Response to request for information for proposed modification to tyre recycling facility at 1-21 Grady Crescent, Erskine Park (MOD 23/0058).

RE: Tyrecycle Modification Noise Assessment – Request for Information

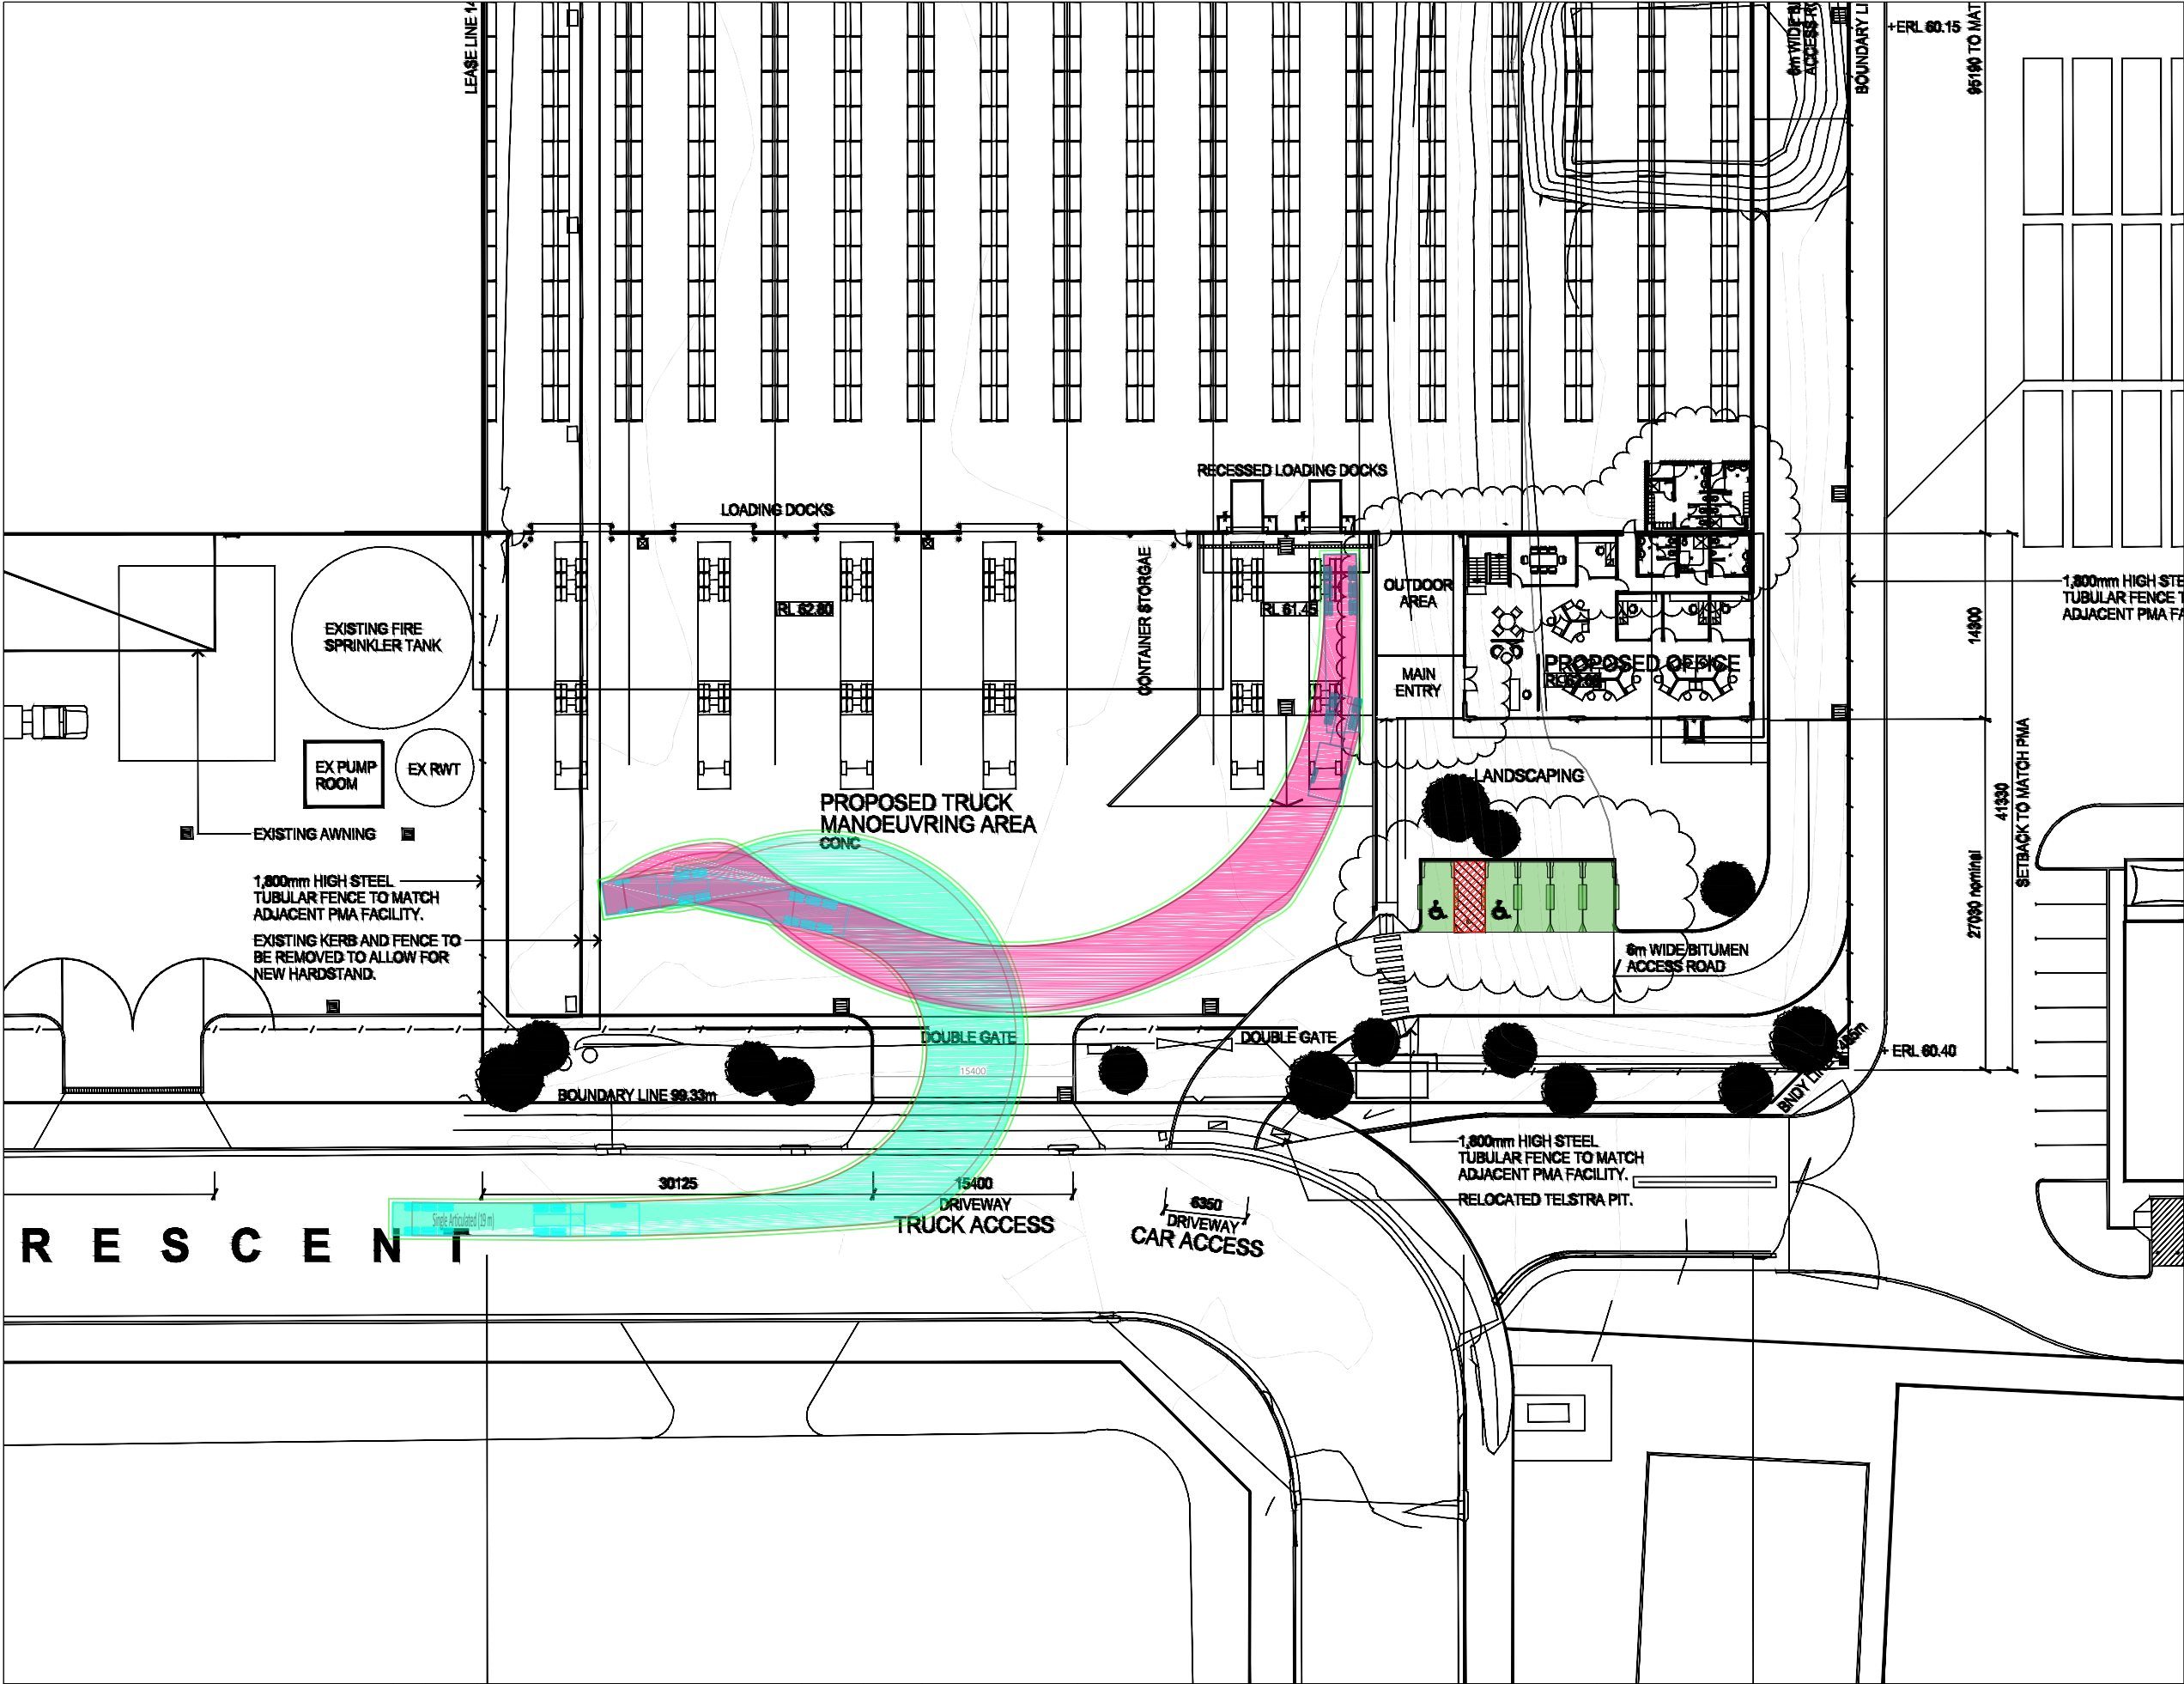
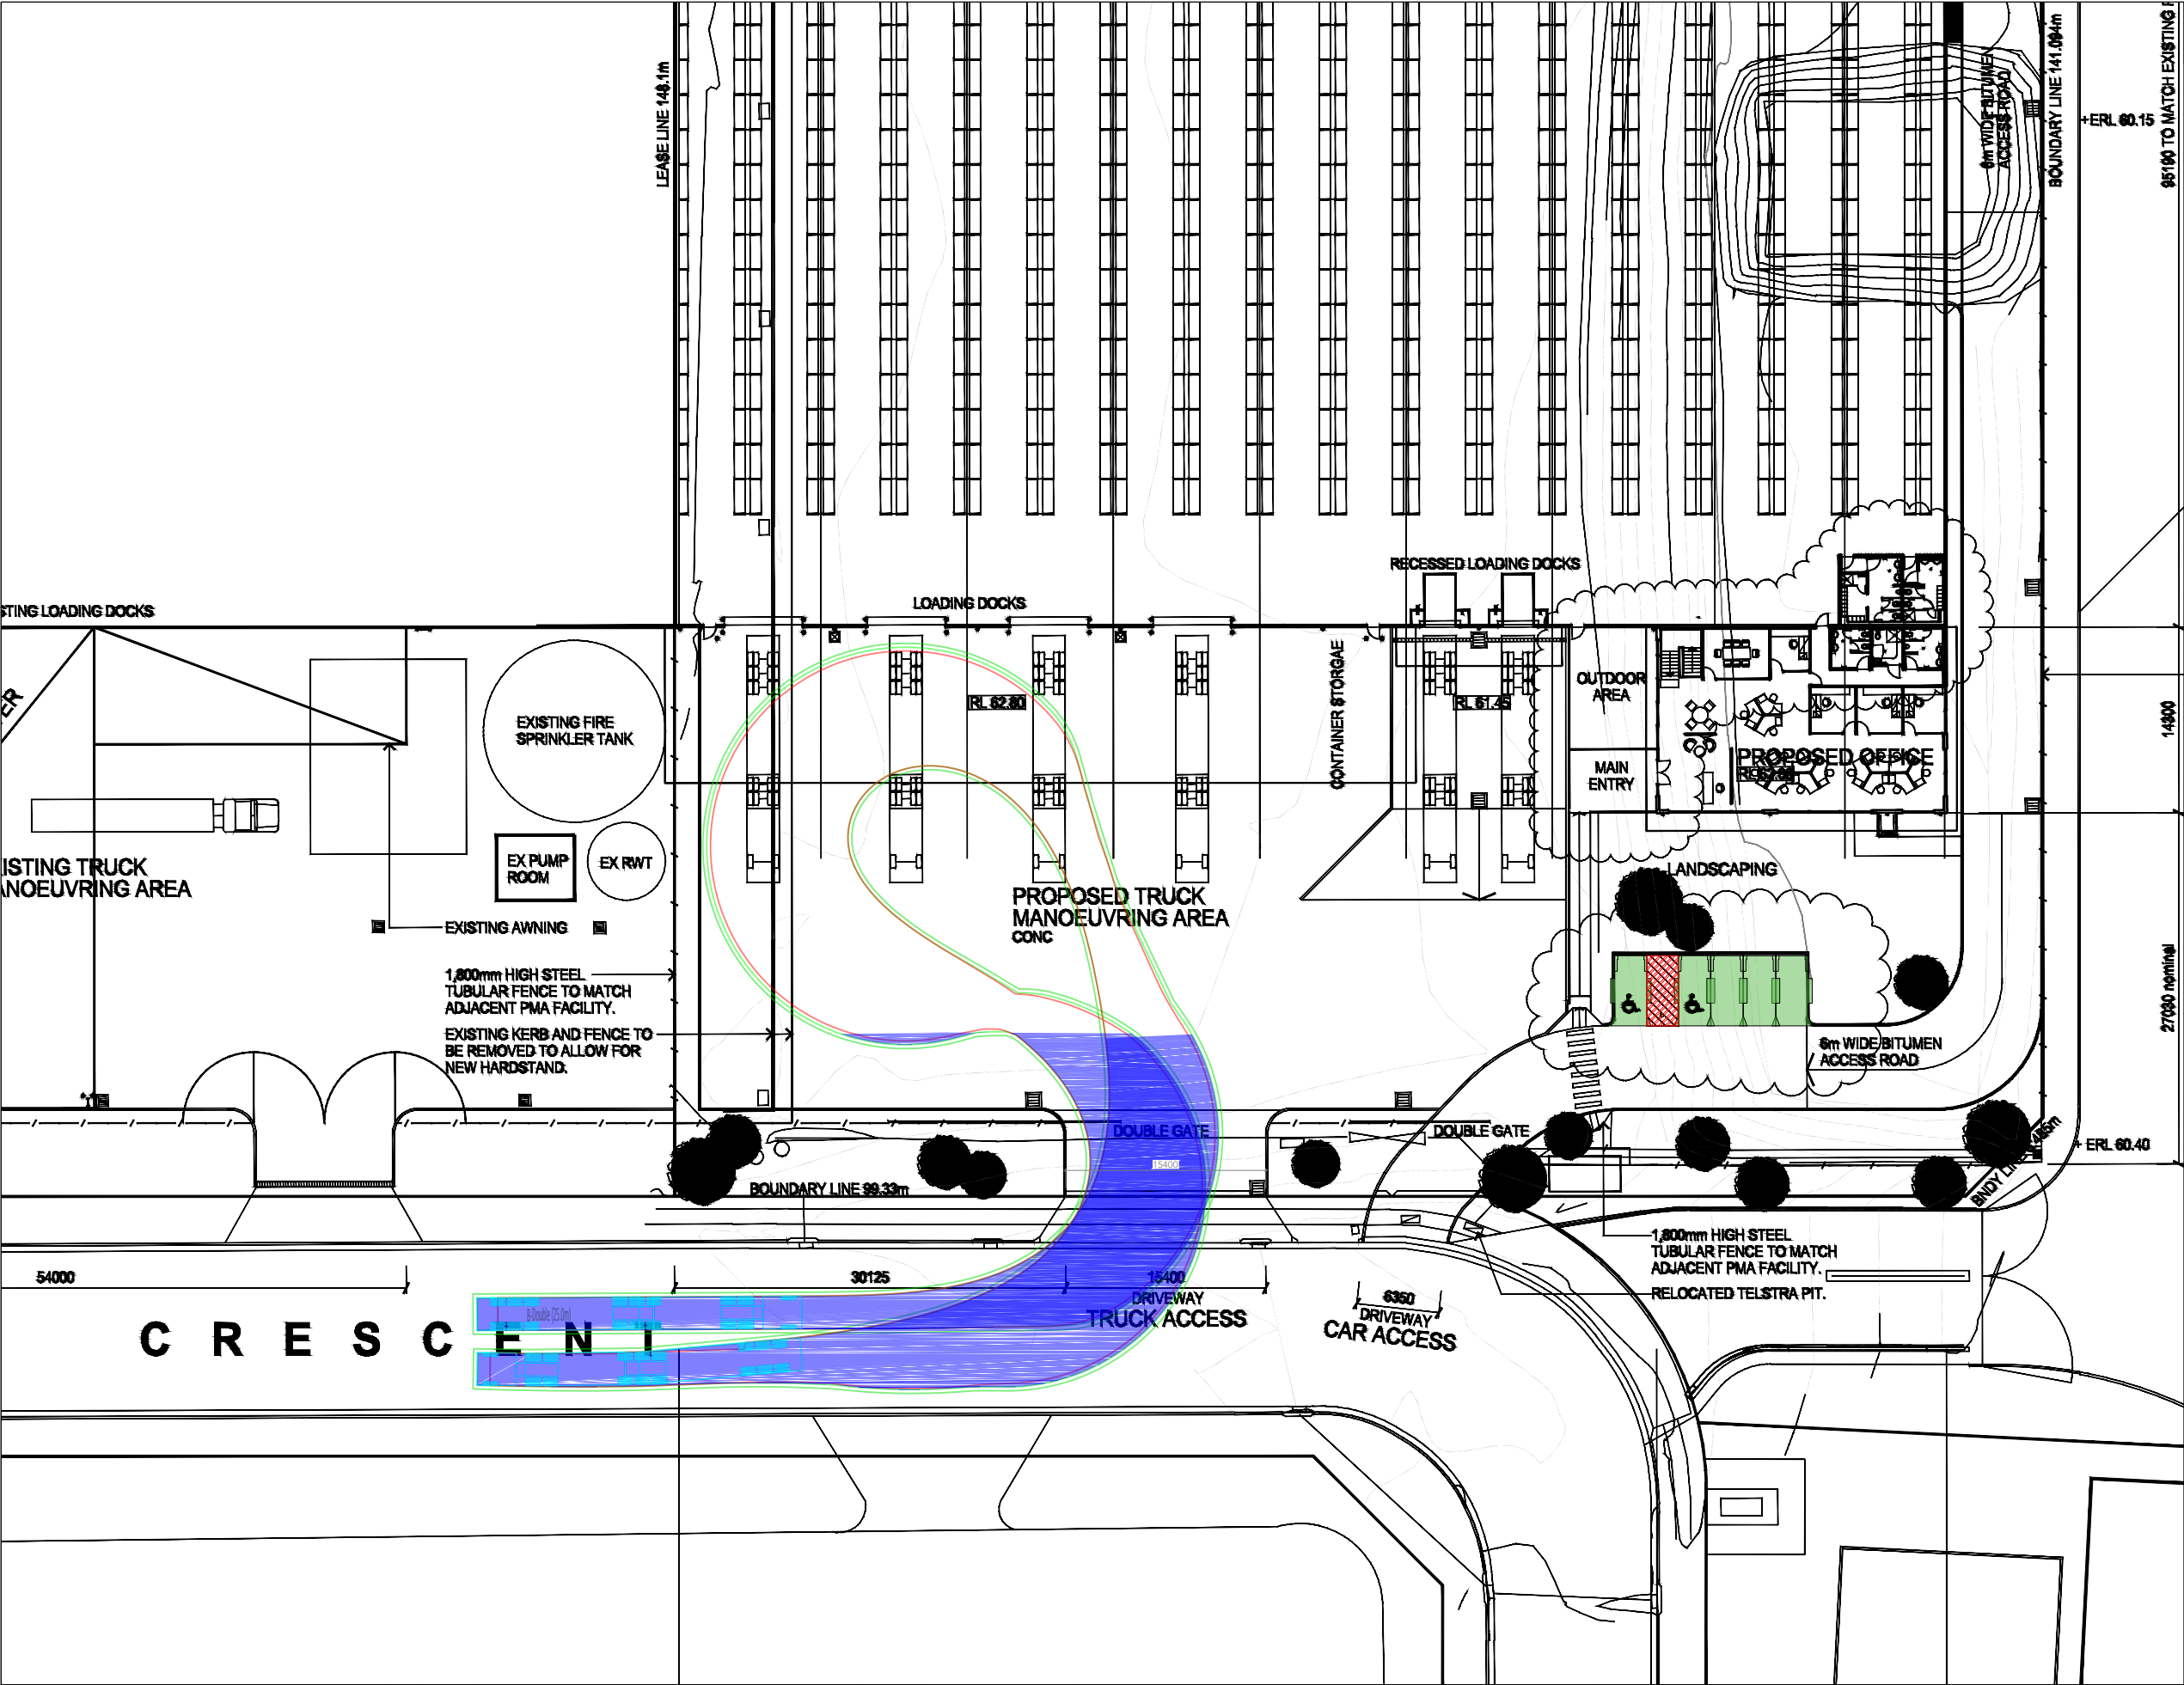
The pre-lodgement advice outlined: "The application shall be supported by turning swept paths in accordance with AS2890 clearly demonstrating satisfactory manoeuvring on-site (both internal and external) for light and heavy vehicles with forward entry and exit to and from the public road, noting the increased use of the loading docks on site."

This information has not been submitted and is therefore requested.

Letter correspondence was provided to Council on 14 November 2022 which clarified certain requirements noted in Council's pre-lodgement meeting minutes dated 15 September 2022. The letter noted that the proposed modification will not require new or additional truck configurations, nor will require an alteration to the approved site development plan or internal maneuverability pathways. As such, the existing and approved swept path diagrams for the development remain applicable and do not require amendment.

This is reiterated in Chapter 4 and Section 5.3.2 of the Statement of Environmental Effects submitted with the application.

The original swept path diagrams approved with the existing development consent are included as Attachment B for ease of reference.
